# **ADDENDUM NO. 1**

# **NCSU** Renovations to the Don Ellis Building

SCO ID# 19-21547 NCSU ID# 201920037 SFK PROJECT NO. 1368-20

December 5, 2023

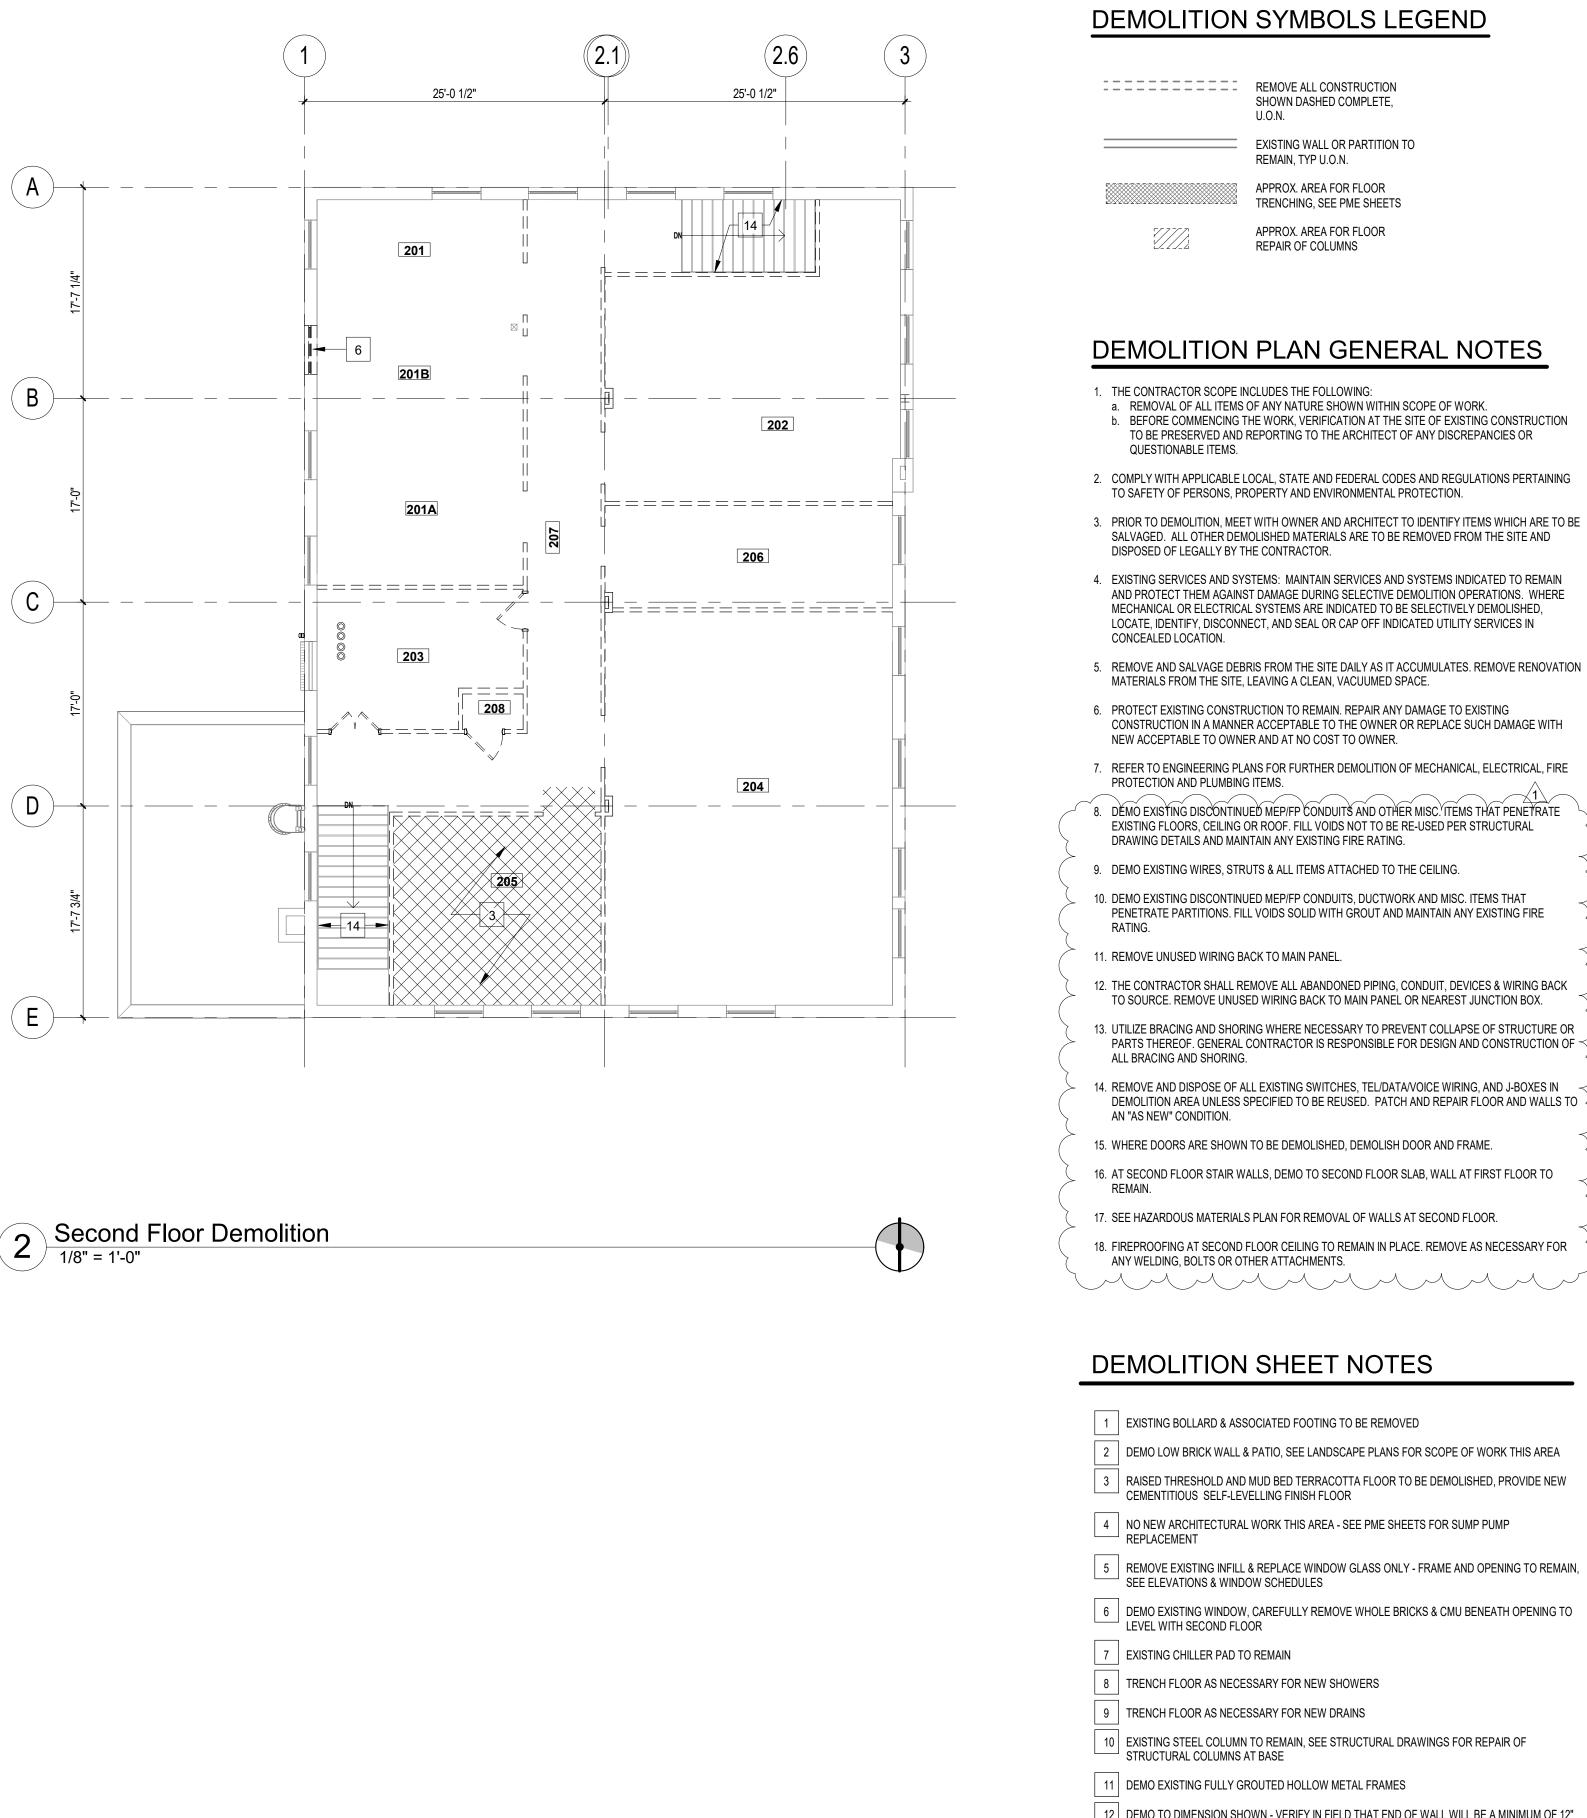
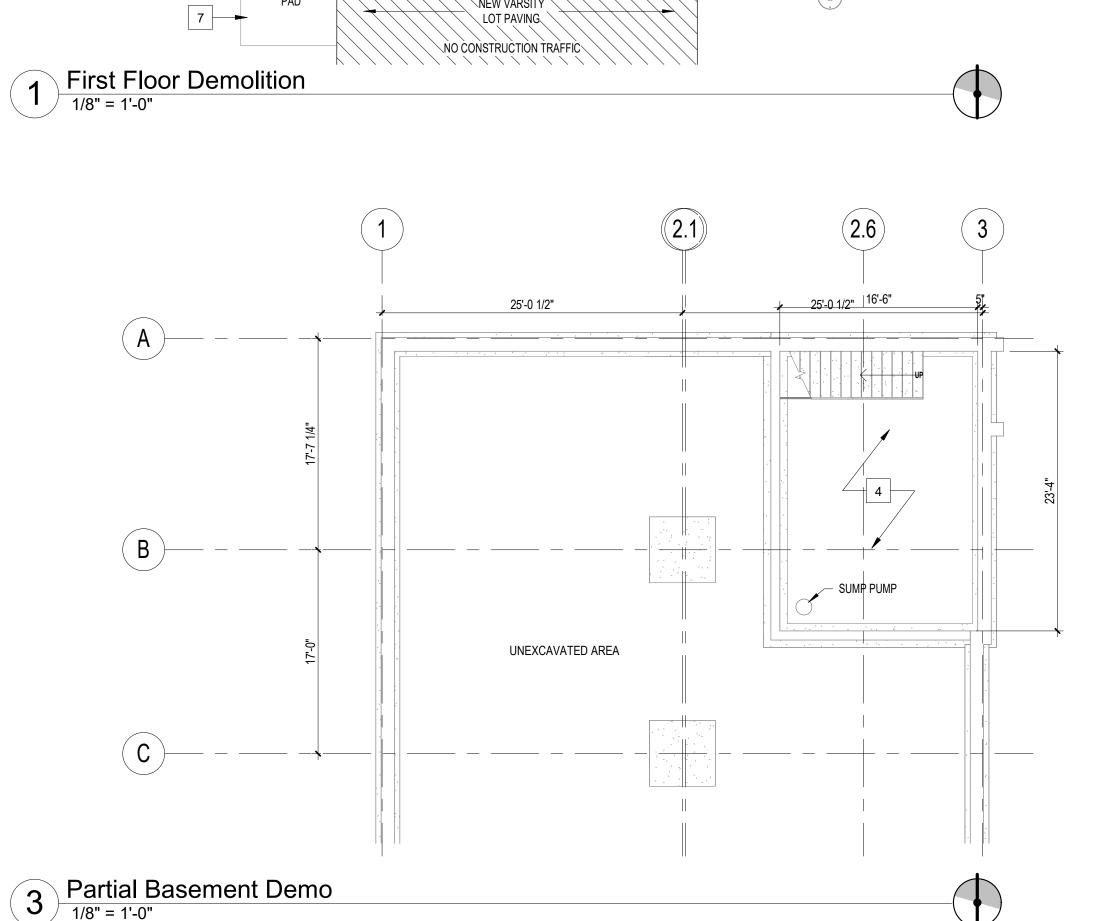
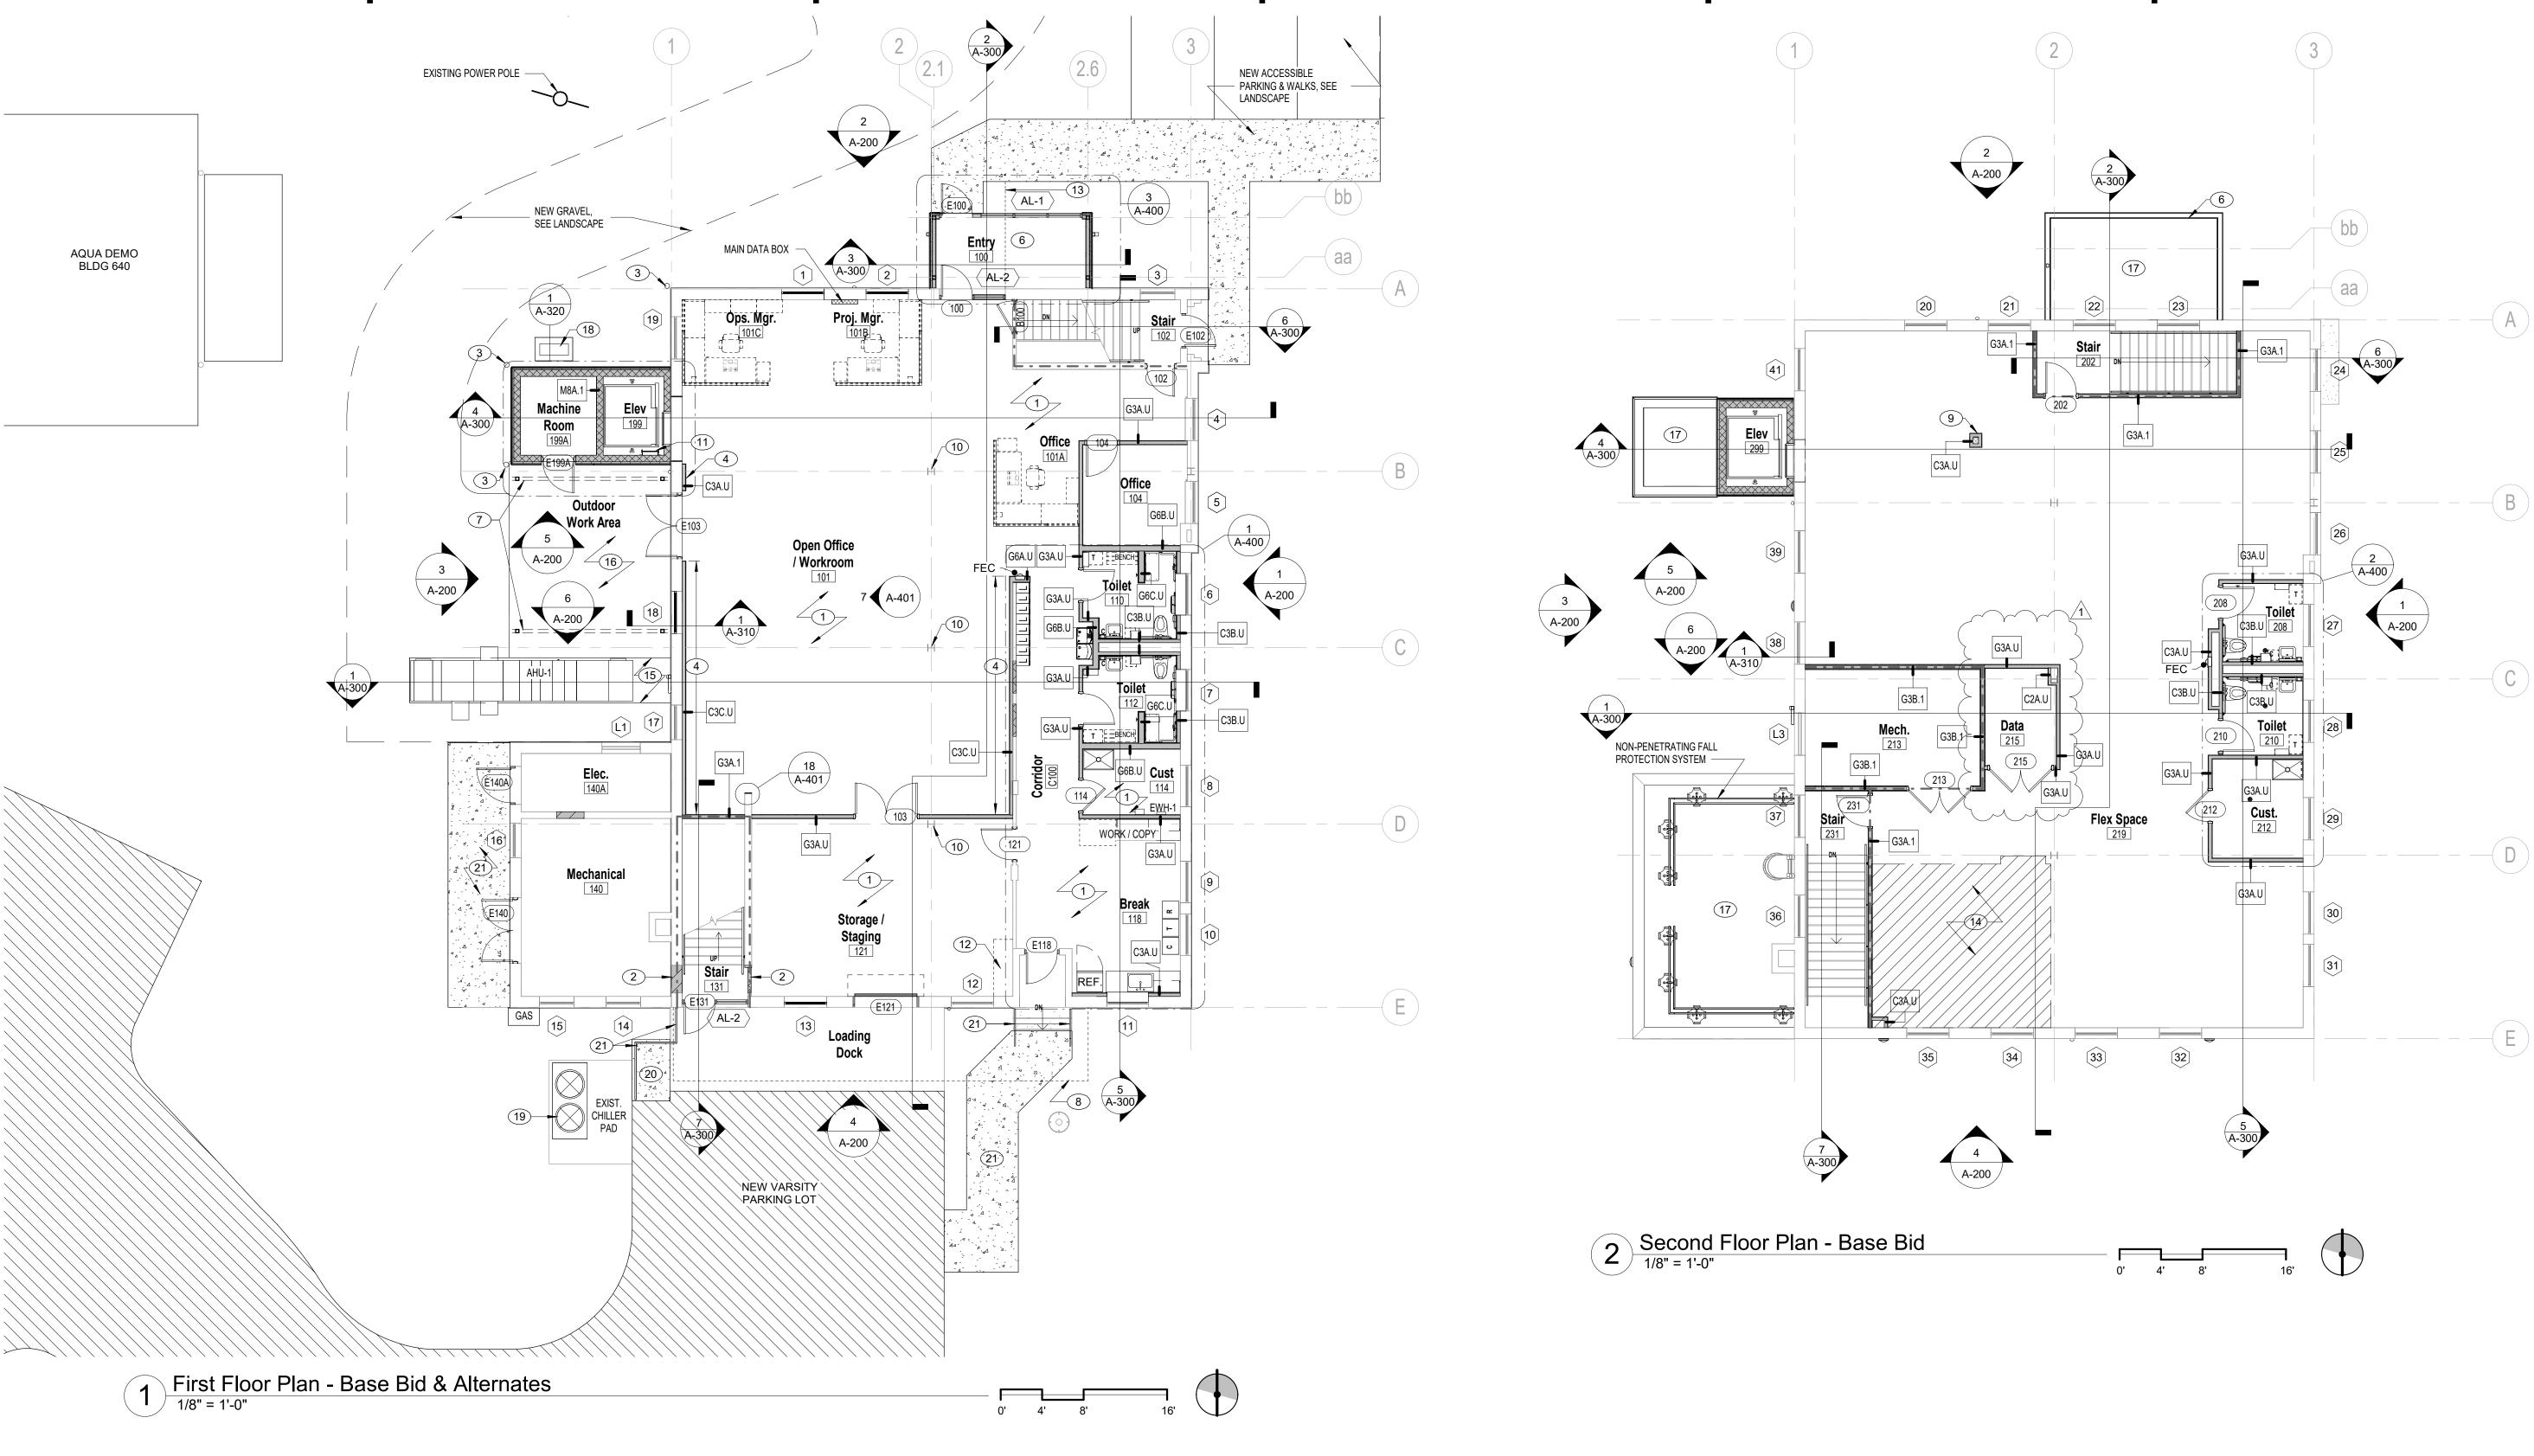
- 1. Sheet D-100: **Replace** with sheet D-100 attached
  - a. Additional notes are added to the sheet
- 2. Sheet A-100: *Replace* with sheet A-100 attached

12 DEMO TO DIMENSION SHOWN - VERIFY IN FIELD THAT END OF WALL WILL BE A MINIMUM OF 12"

BEYOND BEARING OF STAIR BEAM ON WALL. 13 DEMO EXISTING 4" PIPING - REPLACE WITH NEW PIPING TO EXISTING MANHOLE, SEE PME SHEETS

14 REMOVE EXISTING HANDRAILS, CAREFULLY STORE FOR REUSE.
